**Recall 06V429000 - US Units**

**Recall 06-282 – Canada Units**

**Re: Safety Recall – Missing Heat Shield**

**RECALL 06V429000**  
**CANADA # 06-282**  
**LP TANK HEAT SHIELD INSTALLATION**

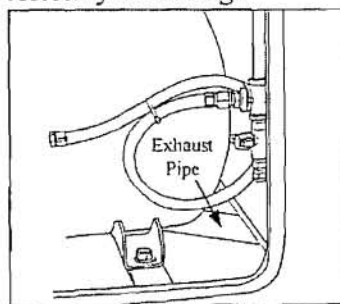
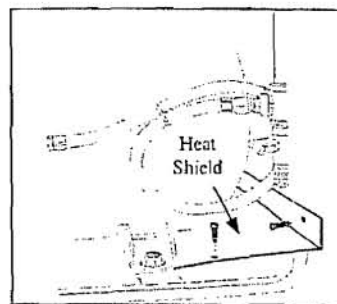
Install a heat shield between the LP tank and the Hydro Hot exhaust pipe to resolve a code violation.

1. Locate LP tank storage bay in front of the passenger side rear tire.
2. Insert supplied heat shield into bay between LP tank mounting feet and bay structure and the front wall of the bay.
3. Secure the heat shield to the outer lip of the LP tank bay surround and the front wall of the bay with 1" X 3/8" self tapping screws supplied.
4. Using black silicone caulking run a bead around the perimeter of the heat shield on the underside to reduce the possibility of rattling.
